**PLANNING COMMISSION STAFF REPORT
MAJOR SUBDIVISION SMF2022 0002
HEARING DATE: DECEMBER 13, 2022**

PROPOSAL: Applicant requests a Modification to the Final Plat regarding Note 9 HOA Bylaws

- SMF2021 0002 was approved on May 11, 2021
- ARF2021 0001 was approved on May 11, 2021
- Applicant seeks to revise the language in Note 9 regarding Homeowners' Association (HOA) Bylaws
- No other modifications are requested

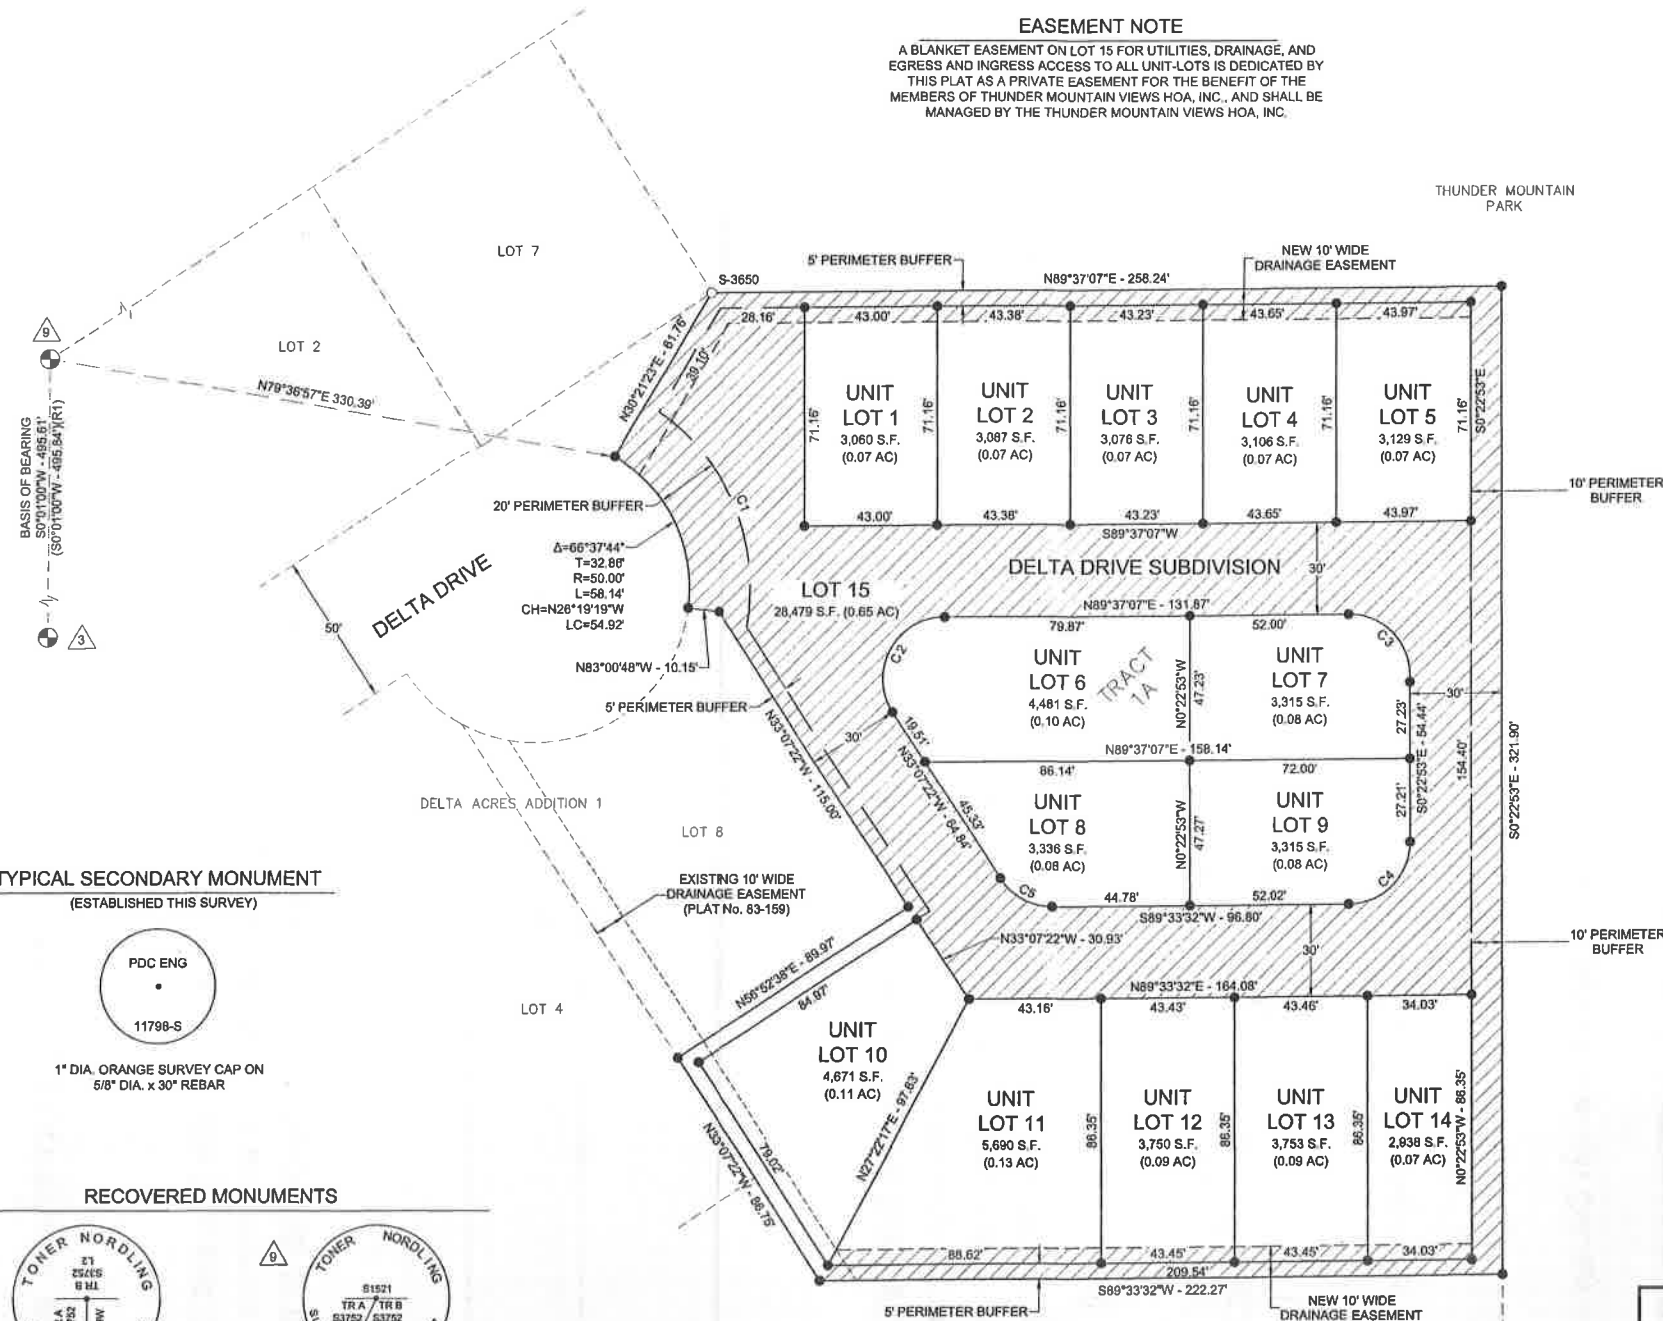
The applicant seeks to modify the language on Plat Note 9 to the following:

THIS PLAT CREATES AN ALTERNATE RESIDENTIAL SUBDIVISION PURSUANT TO AND GOVERNED BY THE CITY AND BOROUGH OF JUNEAU LAND USE CODE TITLE 49 ARTICLE IX. EACH UNIT-LOT IS SUBJECT TO THE BYLAWS OF THUNDER MOUNTAIN VIEWS HOA, INC., AS THEY MAY BE AMENDED. THUNDER MOUNTAIN VIEWS HOA, INC. HAS A LIEN ON A UNIT-LOT FOR AN ASSESSMENT LEVIED AGAINST THE UNIT-LOT FROM THE TIME THE ASSESSMENT BECOMES DUE WITH THE SAME RIGHTS AS PROVIDED UNDER AS 34.08.470 FOR ASSOCIATIONS OF COOPERATIVES WHOSE UNIT OWNERS' INTERESTS IN THE UNITS ARE REAL ESTATE. EACH OWNER OF A UNIT-LOT IS REQUIRED TO, AND SHALL BE, THROUGHOUT THEIR OWNERSHIP, A MEMBER OF THE THUNDER MOUNTAIN VIEWS HOA, INC., AND IS REQUIRED TO PAY ASSESSMENTS ASSESSED BY THUNDER MOUNTAIN VIEWS HOA, INC. THE ANNUAL AVERAGE COMMON EXPENSE LIABILITY OF A MEMBER, EXCLUSIVE OF ANY INSURANCE PREMIUMS PAID BY THE ASSOCIATION, MAY NOT EXCEED \$100, AS ADJUSTED UNDER AS 34.08.820.
